CLEVELAND NATIONAL FOREST POWER LINE REPLACEMENT PROJECTS

MINOR PROJECT REFINEMENT REQUEST FORM

Date Submitted:	03-06-20	Request #:	46
Date Approval Required:	03-20-20	Landowner:	Tulloch Family Partners LP
APN:	412-060-01, 412-020-02, and 412-010-02		
Refinement from (check all that apply):			
<input type="checkbox"/> Mitigation Measure	<input type="checkbox"/> APM	<input checked="" type="checkbox"/> Project Description	<input type="checkbox"/> Drawing <input checked="" type="checkbox"/> Other
Identify source (mitigation measure, project description, etc.):			
<p>Notice to Proceed (NTP) request #23 for Phase I Overhead of Circuit (C) 440 of the Cleveland National Forest Power Line Replacement Projects (Project) was approved by the United States Forest Service (USFS) on June 28, 2019 and by the California Public Utilities Commission (CPUC) on July 11, 2019. Since this approval, San Diego Gas & Electric Company (SDG&E) has identified additional anchors needed to reduce blowout (i.e., horizontal movement of conductors) and access road modifications along Phase I Overhead of C440. A brief description and justification of the refinements are provided on page 2 of this MPR request.</p>

**Attachment B:
Comparison Map
Phase I Overhead of C440 Map 2 of 7**

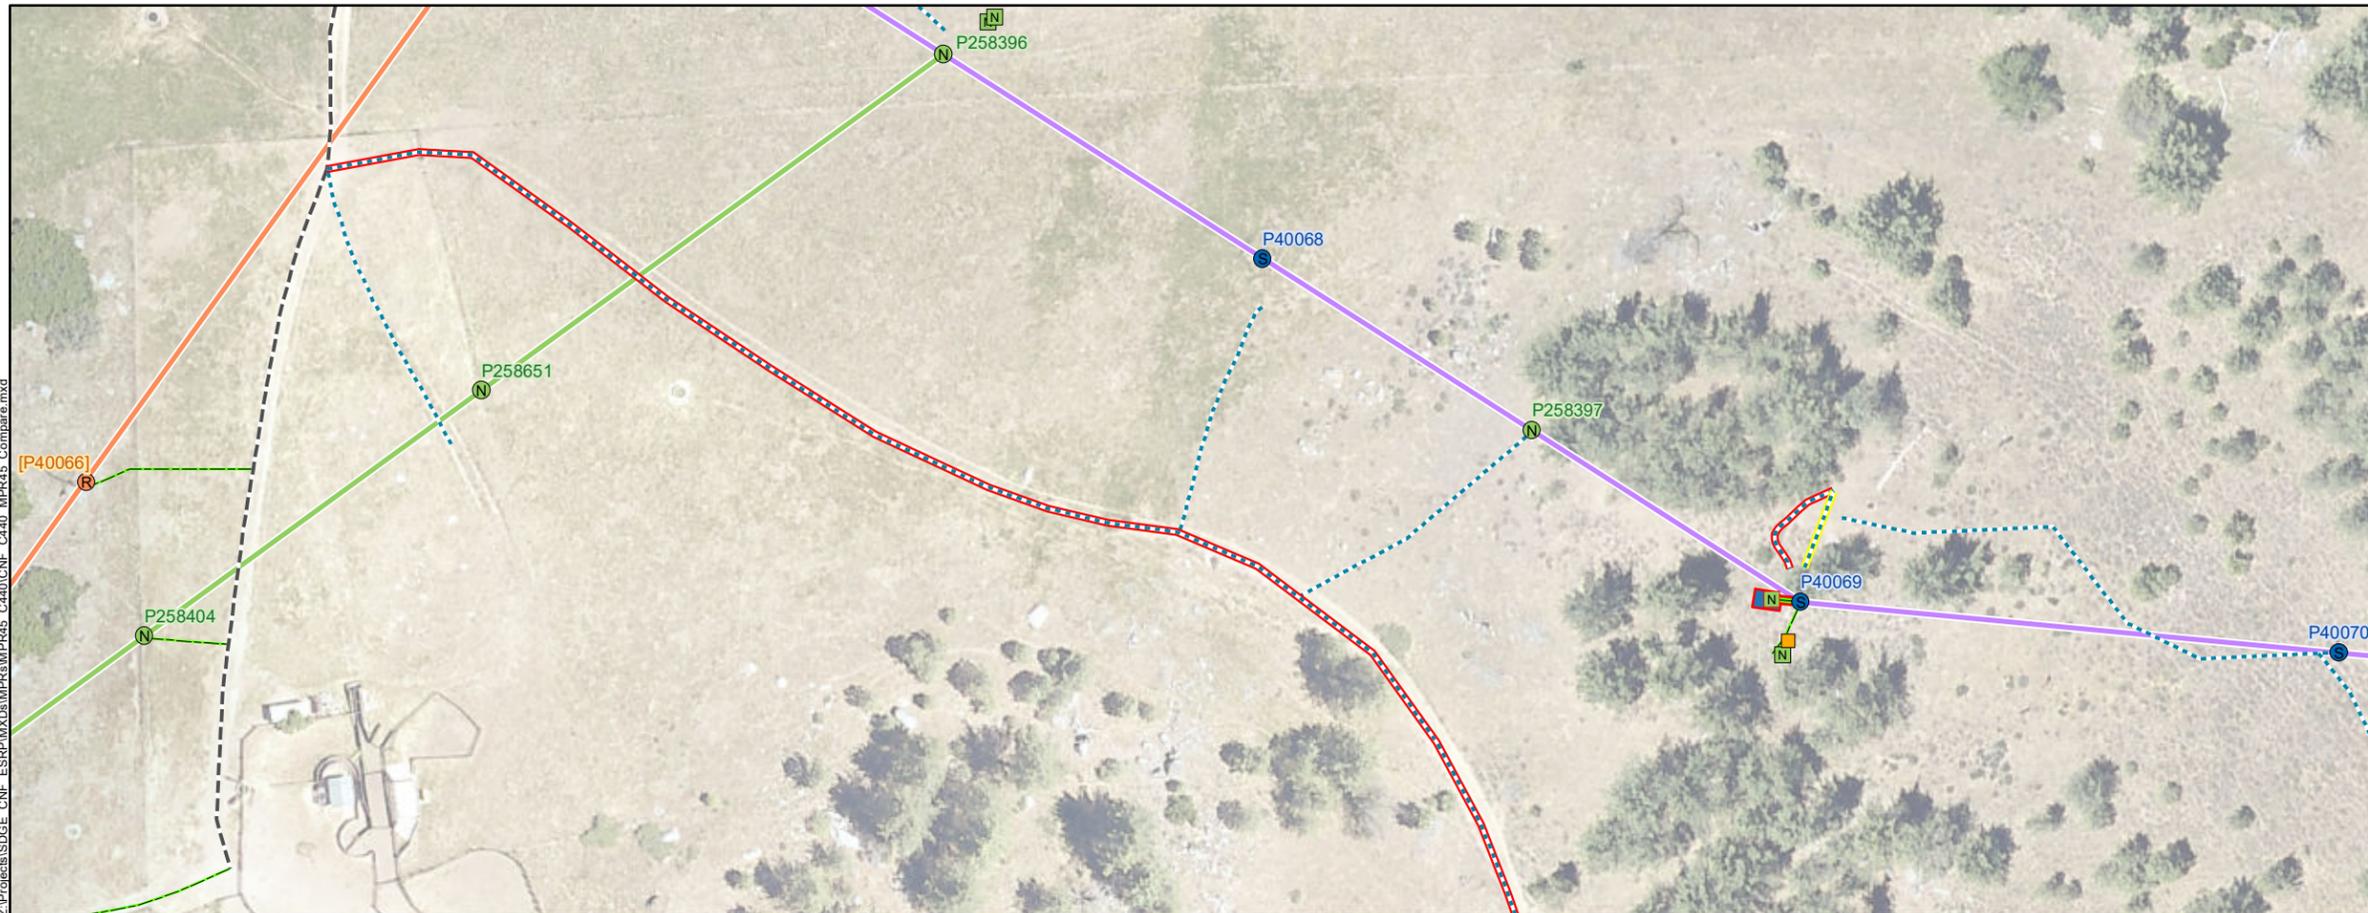
-  New Anchor
-  Anchor Work Area
-  Footpath
-  Construction-Only Access Road
-  Construction-Only Access Road (No Longer Needed)

**Attachment B:
Comparison Map
Phase I Overhead of C440 Map 3 of 7**

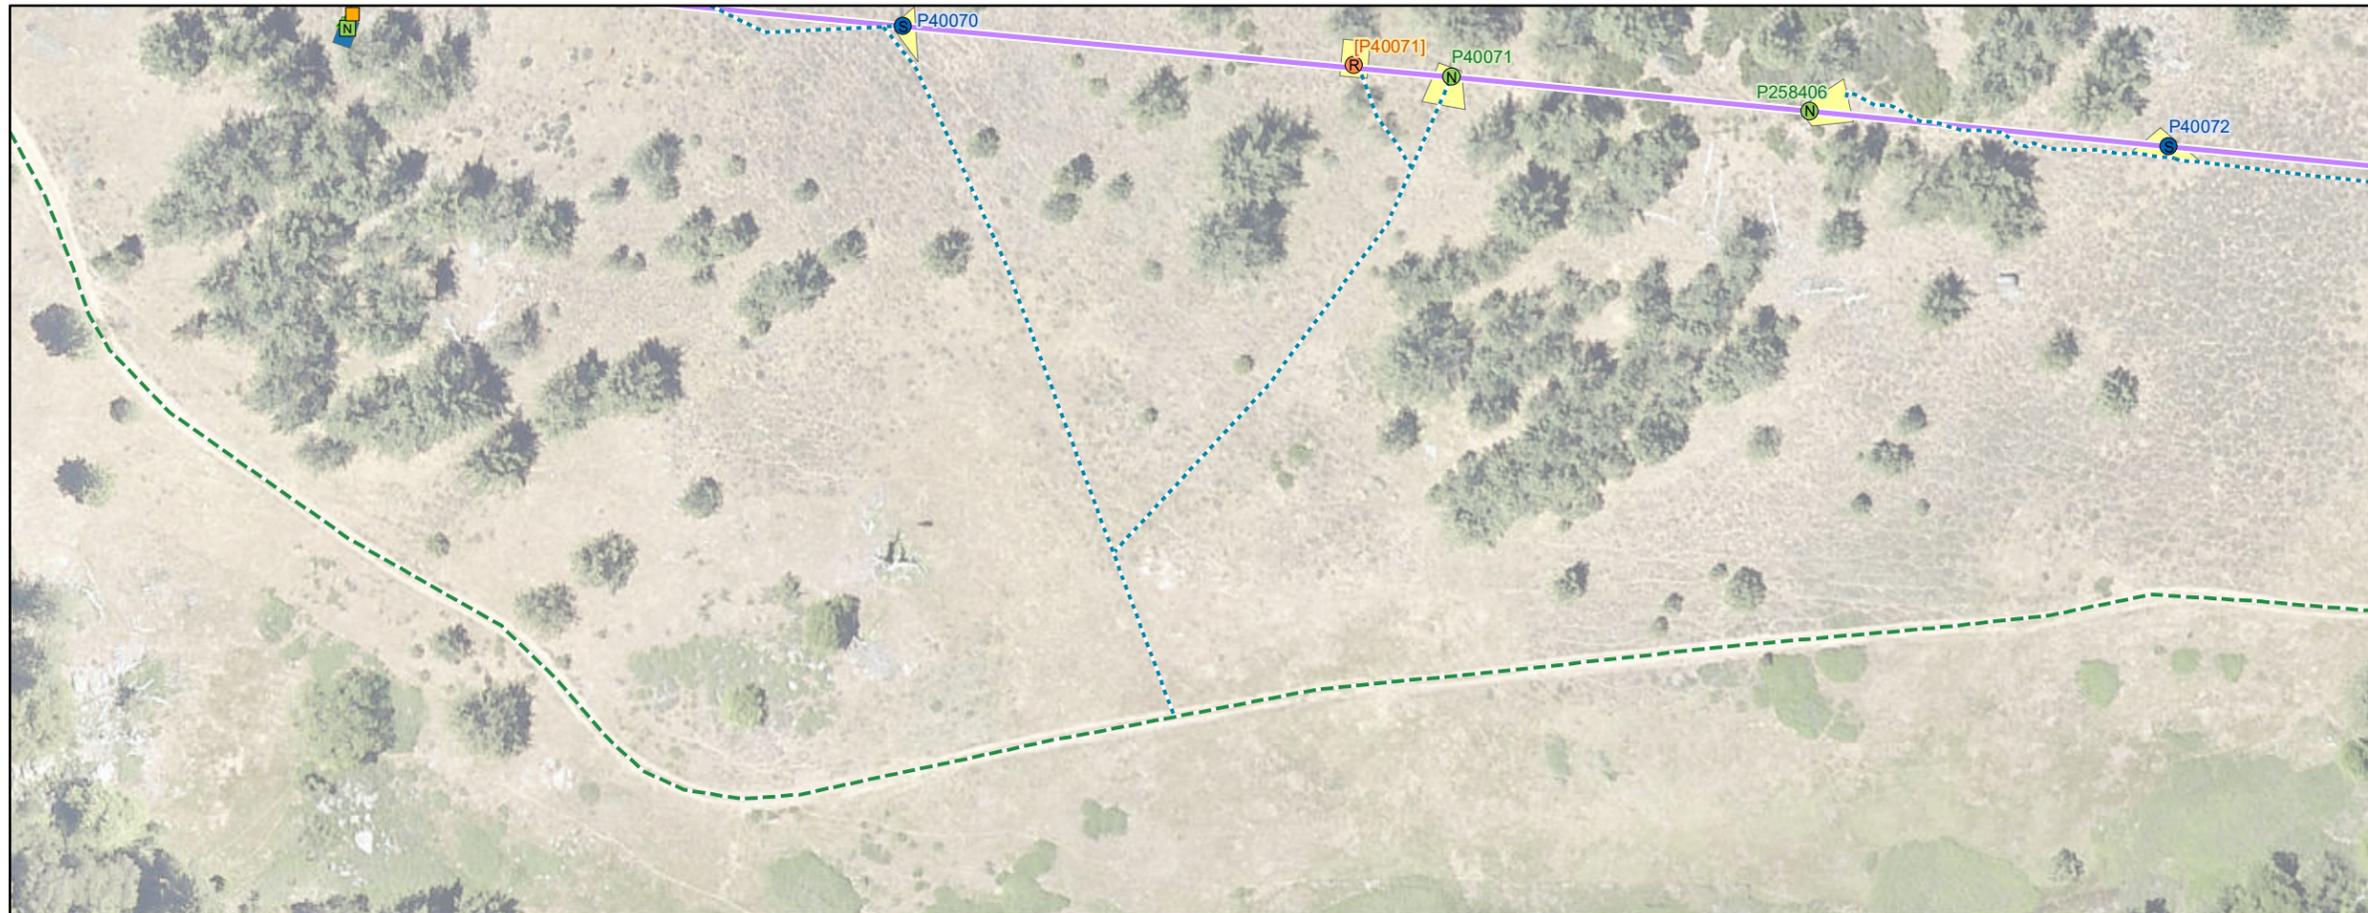
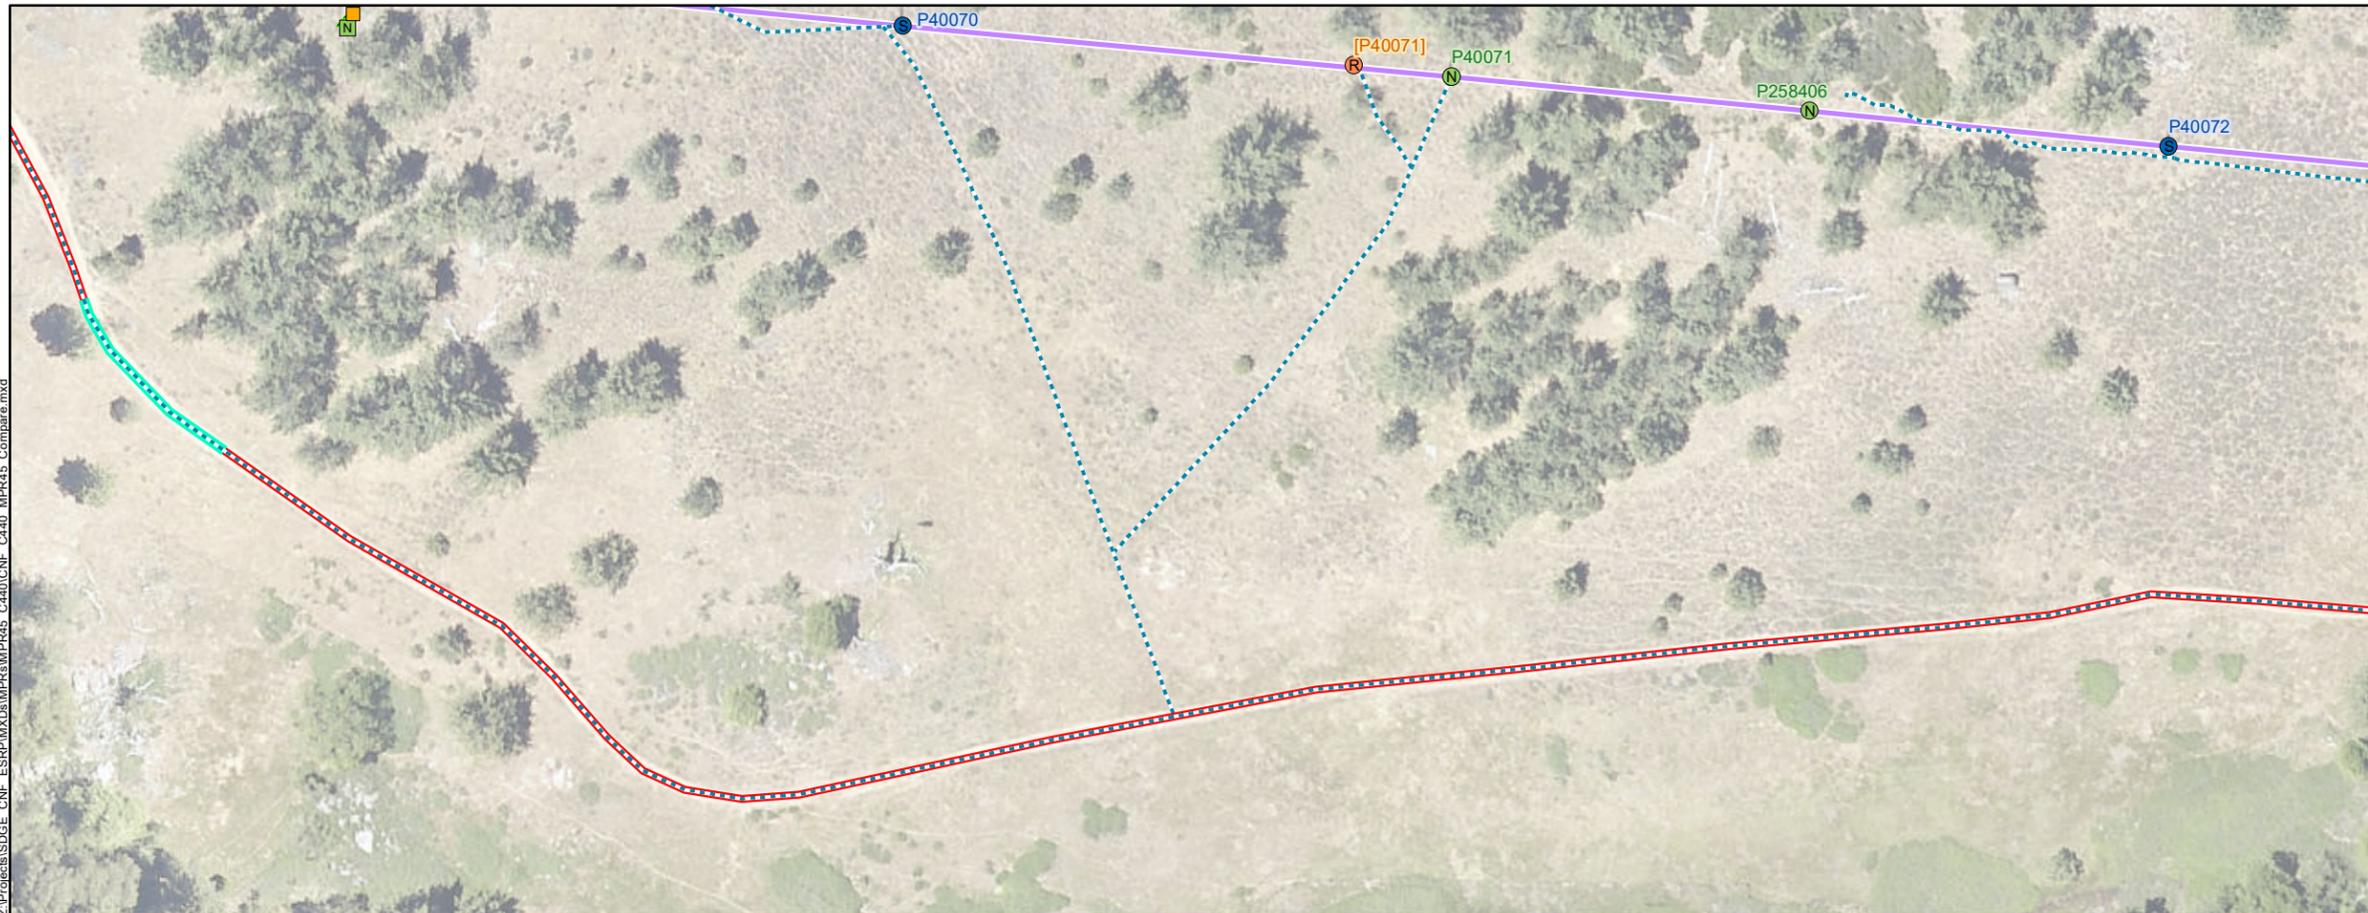
- Final Design**
- NTP #23**
- Wood-to-Steel Replacement 12 kV Only
 - Removal
 - New Steel Pole
 - New Anchor
 - Remove from Service Anchor
 - Construction-Only Access Road
 - Footpath
 - Wood-to-Steel Replacement
- MPR #46**
- Construction-Only Access Road (No Grading)
 - Construction-Only Access Road

**Attachment B:
Comparison Map
Phase I Overhead of C440 Map 4 of 7**

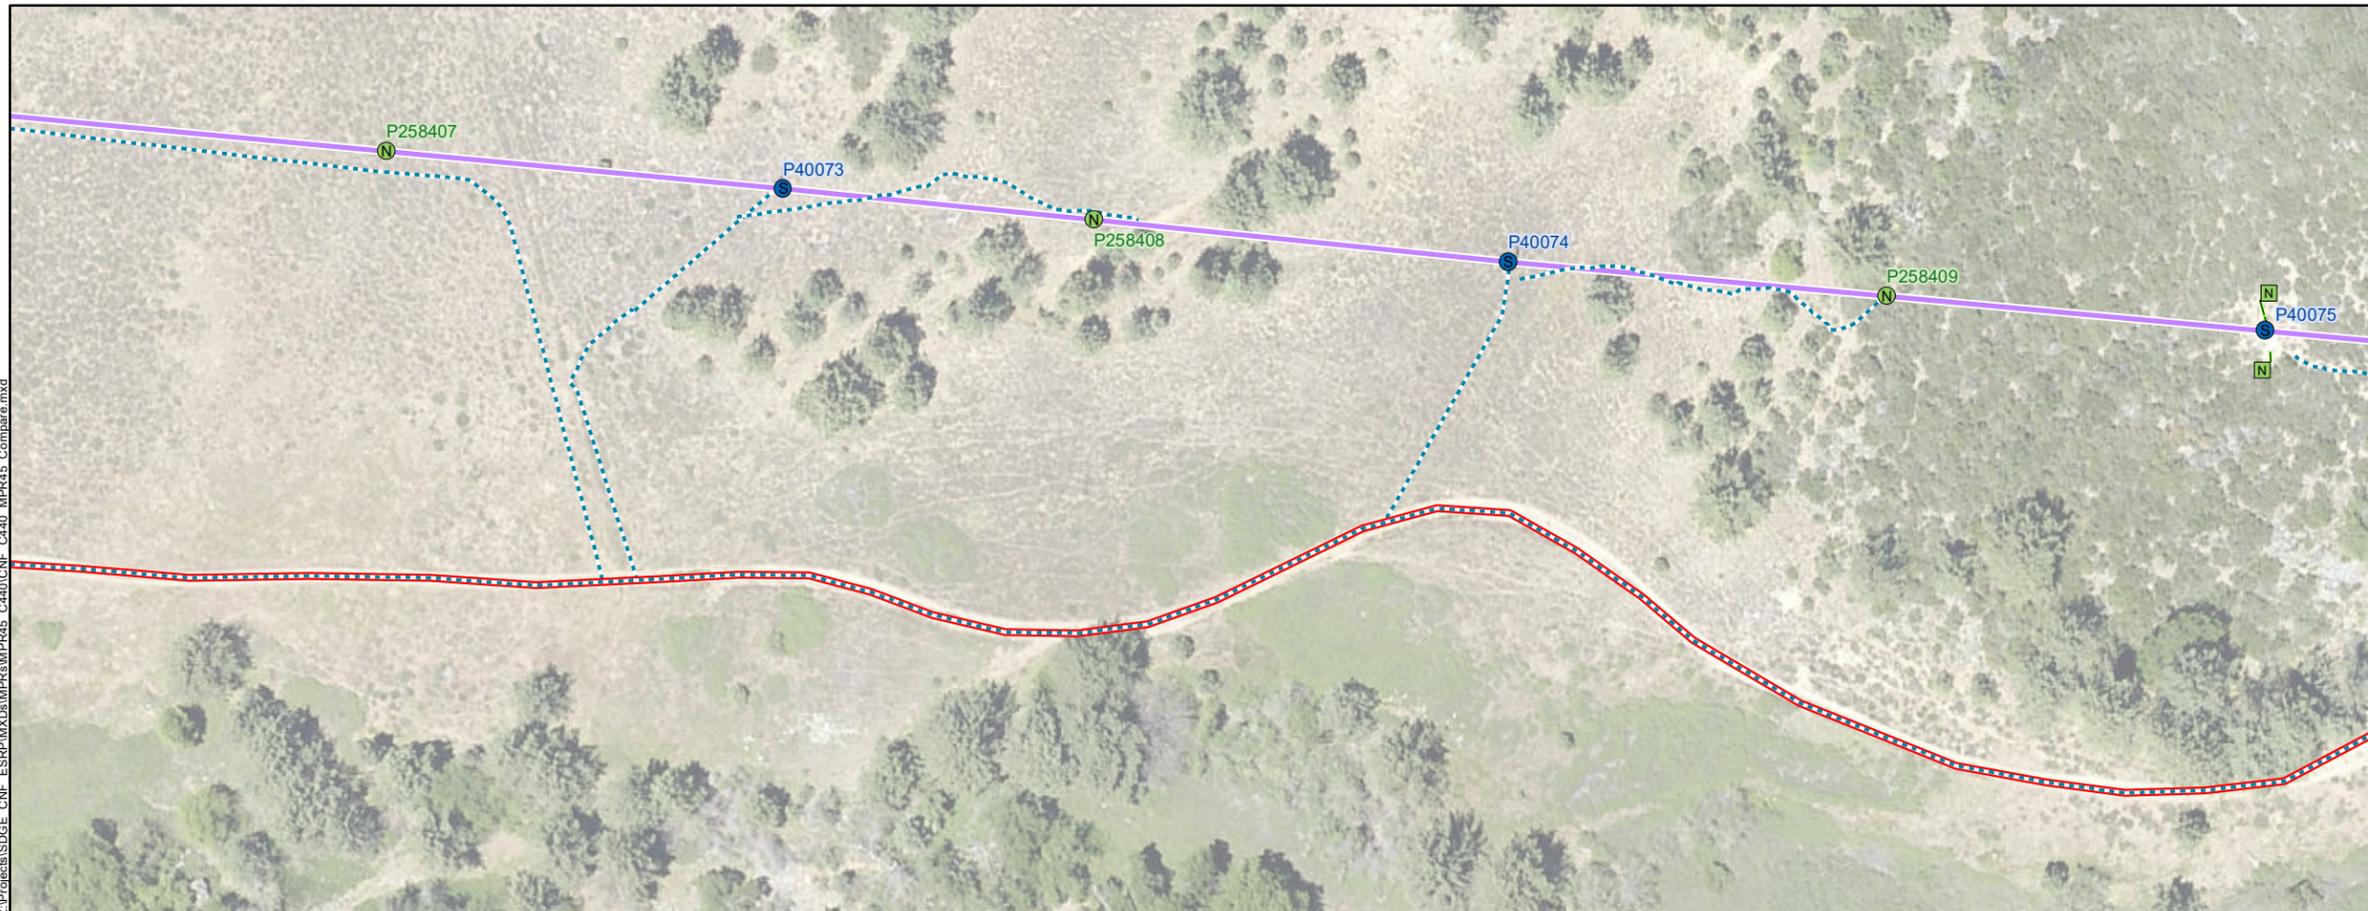
- Final Design**
- NTP #23**
-  Wood-to-Steel Replacement 12 kV Only
 -  New Steel Pole
 -  New Anchor
 -  Construction-Only Access Road
 -  Footpath
 -  Wood-to-Steel Replacement
- MPR #46**
-  Construction-Only Access Road
